Midtown Filing 13 – Case number PRC2023-00023

Response Memo Dated 01-19-2024

MIDTOWN FILING 13 PLANNED UNIT DEVELOPMENT - FINAL DEVELOPMENT PLAN

SHEET 3 OF 9

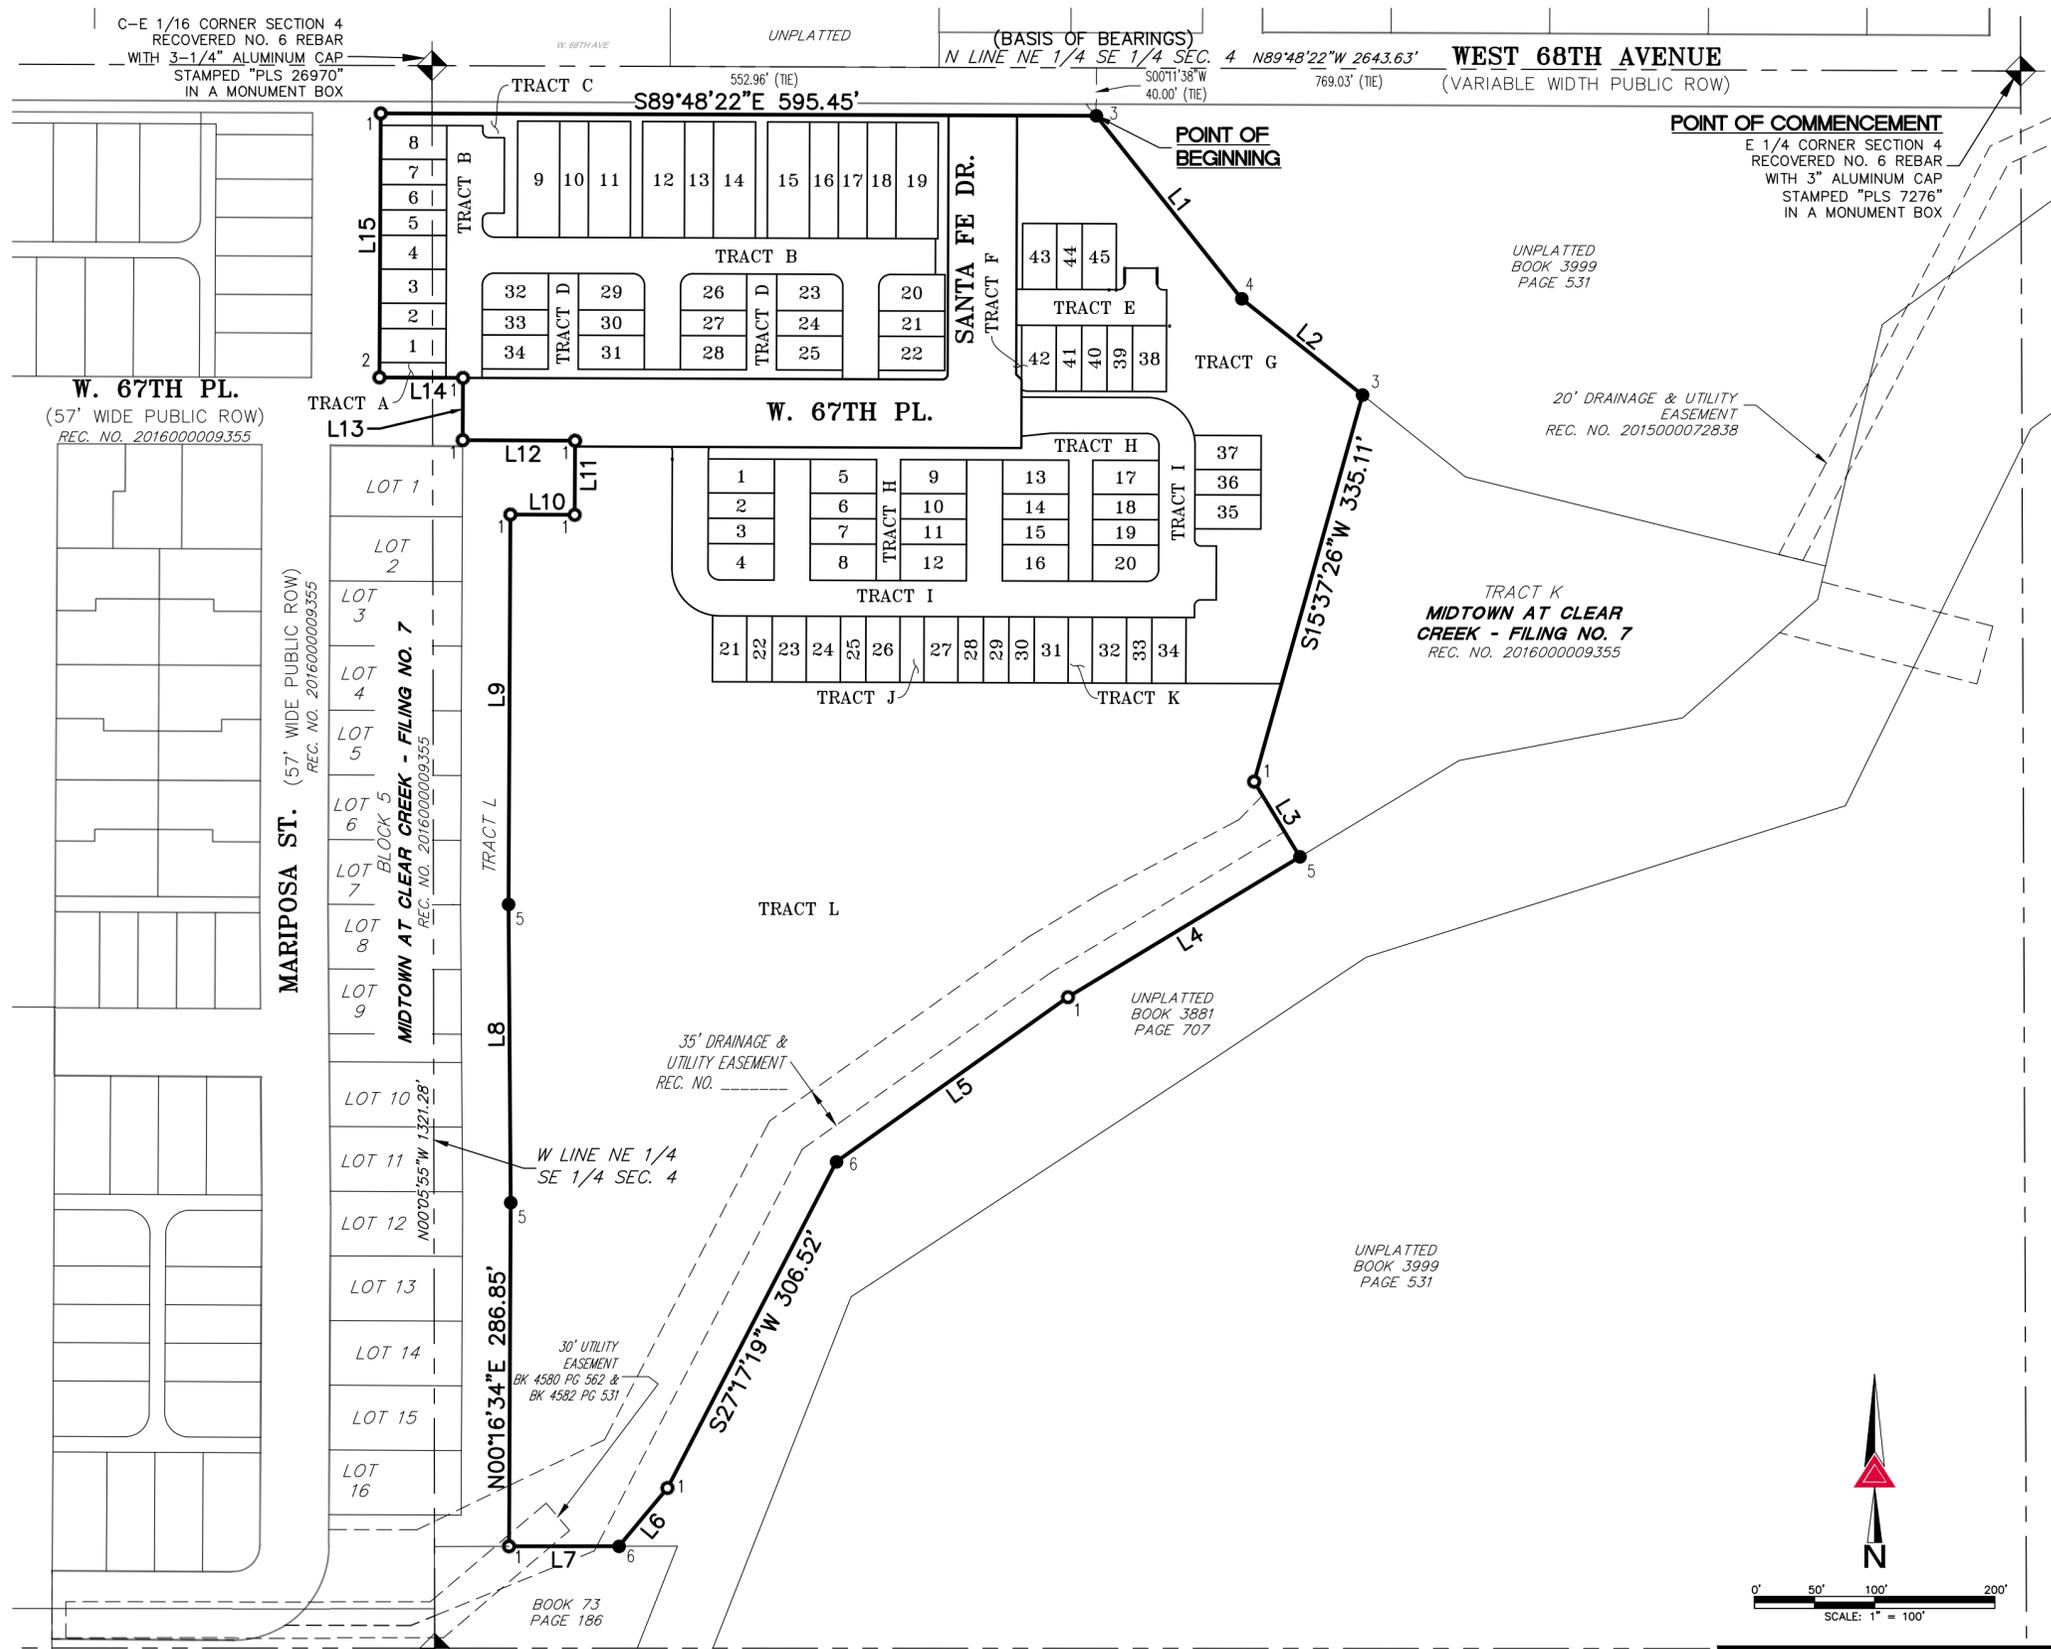
- Pg 3 – Correct Line Table, L11 to reflect correct distance of 61.88 Feet **Revised**
- Pg 7 – Bottom of page where it says 'See Sheet 2' I believe should say ' See Sheet 3' as that's the only page that shows all of Tract L **Revised**

SHEET 3 OF 9

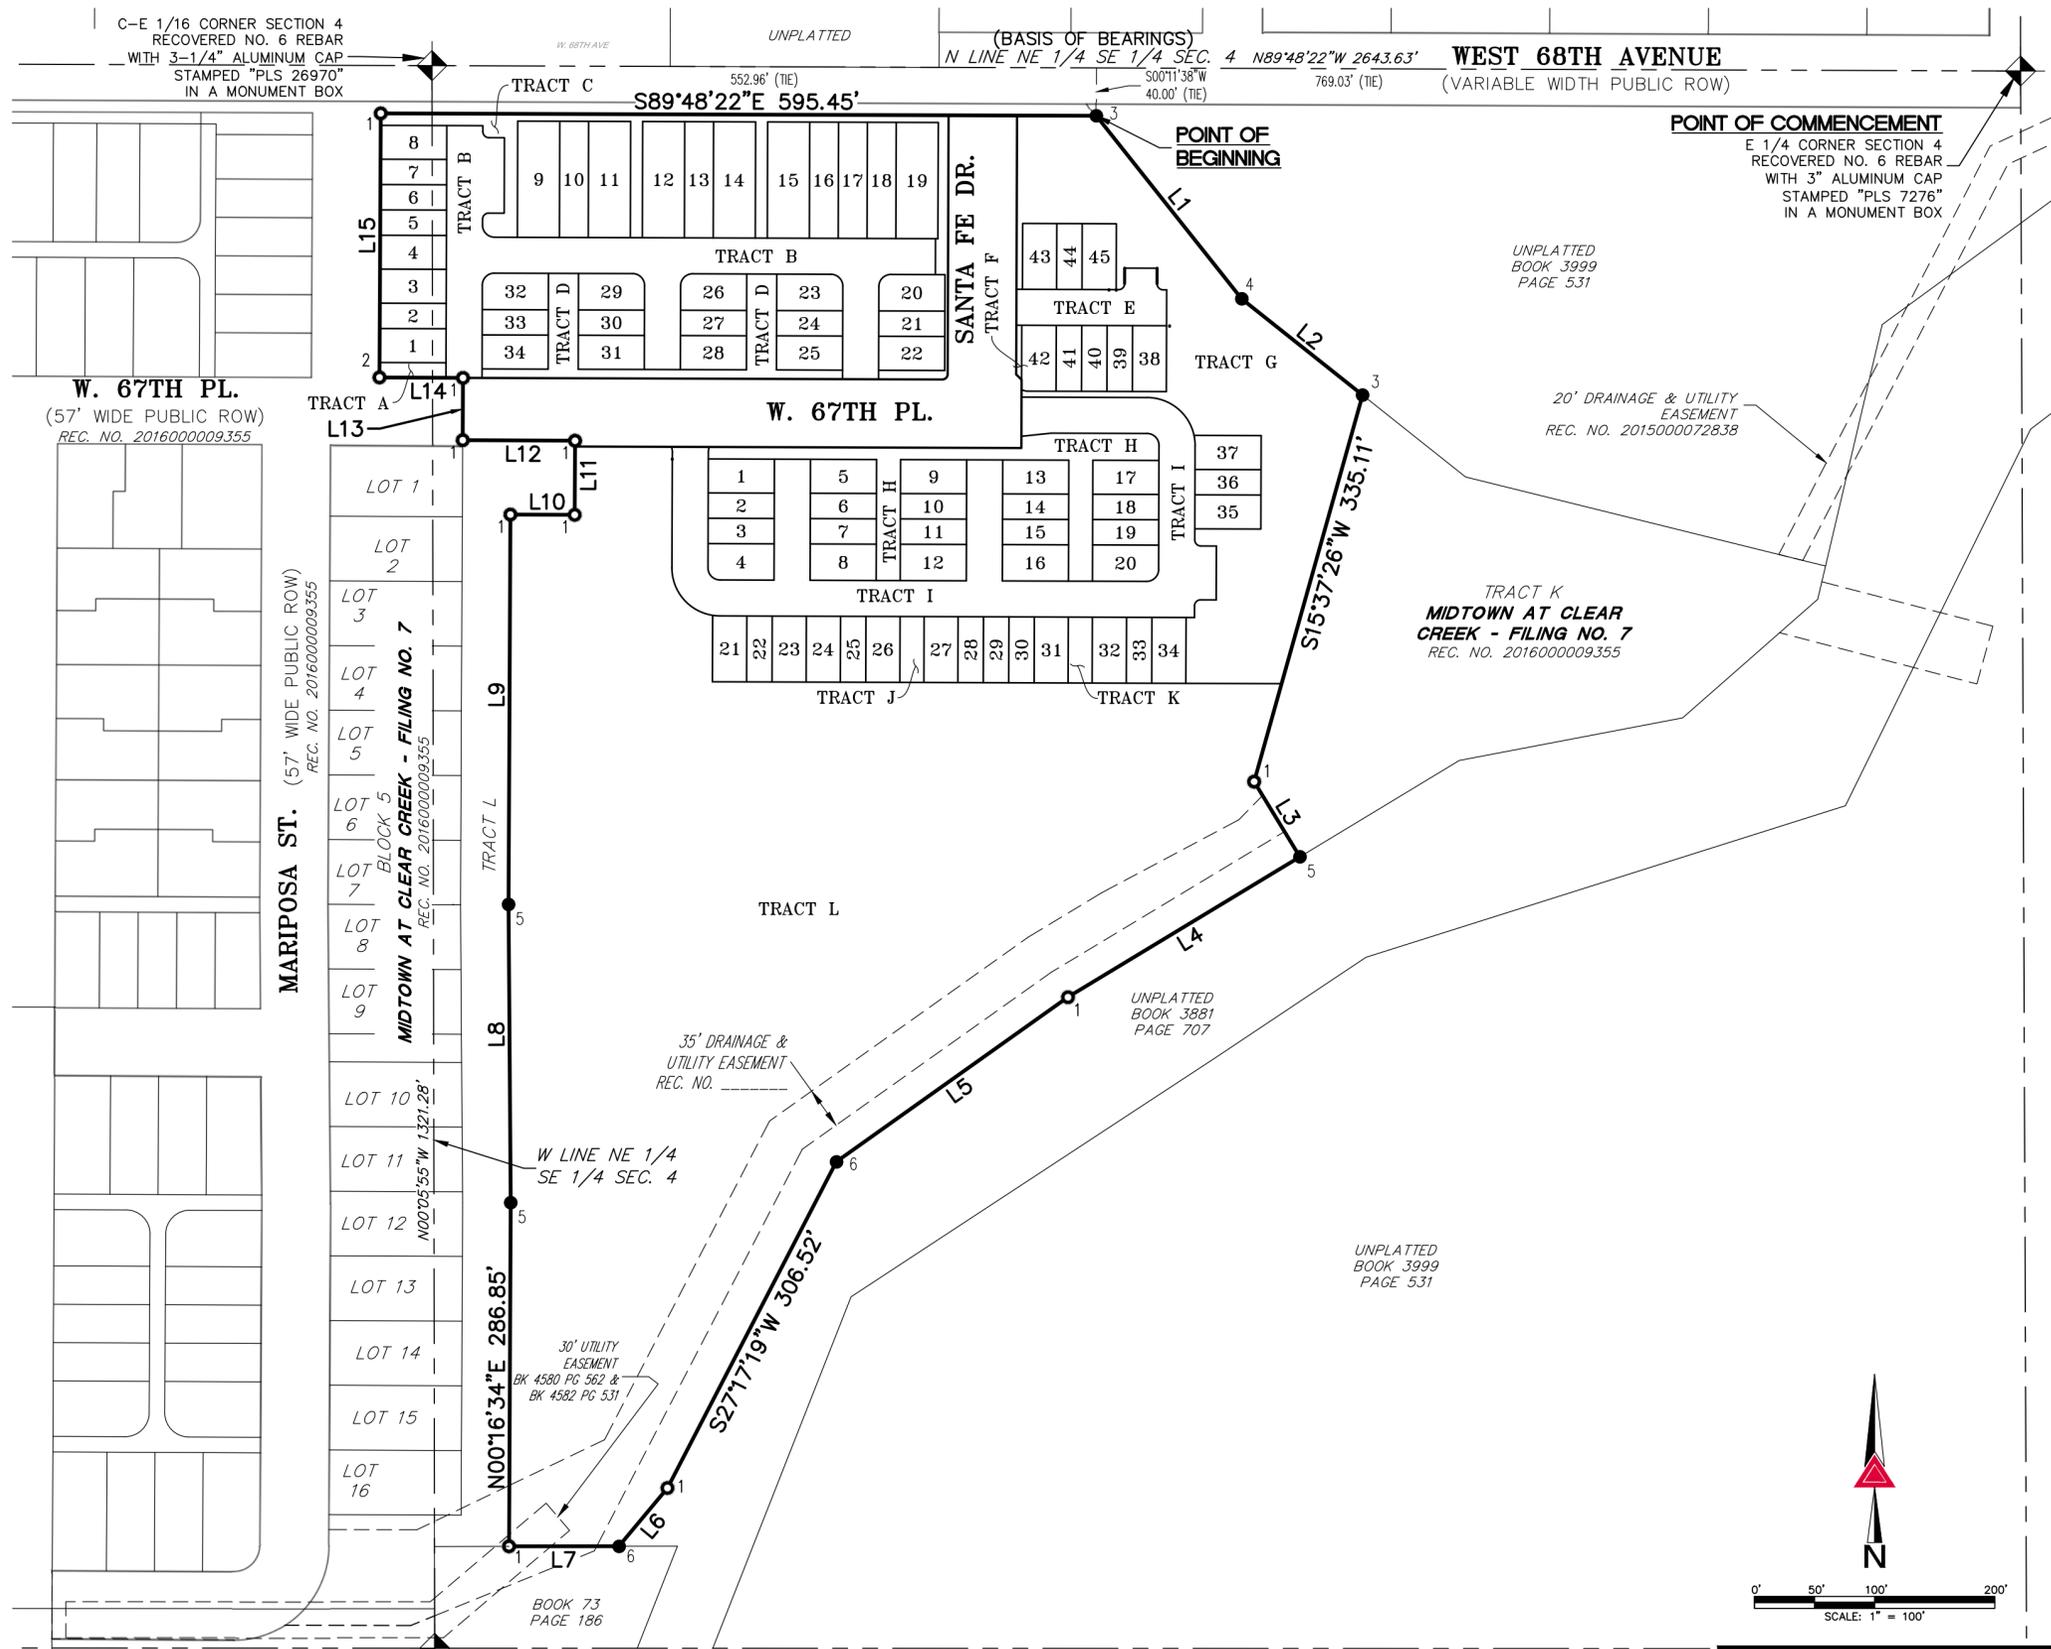
- Pg 3 – Correct Line Table, L11 to reflect correct distance of 61.88 Feet **Revised**
- Pg 7 – Bottom of page where it says 'See Sheet 2' I believe should say ' See Sheet 3' as that's the only page that shows all of Tract L **Revised**
